UNITED STATES PATENT AND TRADEMARK OFFICE

APPLICATION NO.	FILING DATE	FIRST NAMED INVENTOR	ATTORNEY DOCKET NO.	CONFIRMATION NO.
10/663,889	09/16/2003	Kerry Stephen McClure	27735-11	4514
24256	7590	12/15/2005	EXAMINER	
DINSMORE & SHOHL, LLP 1900 CHEMED CENTER 255 EAST FIFTH STREET CINCINNATI, OH 45202			LARSON, JUSTIN MATTHEW	
			ART UNIT	PAPER NUMBER
			3727

Office Action Summary

movement path. The outer edge (A) is shown in the figure below, taken from Fukushima et al., Figure 6.

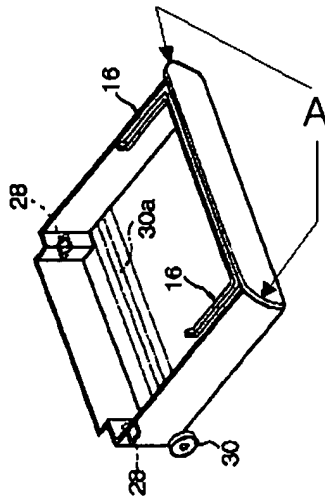
14. Regarding claim 6, Fukushima et al. discloses an outer edge on the support member, the outer edge extending outwardly and generally perpendicularly from the
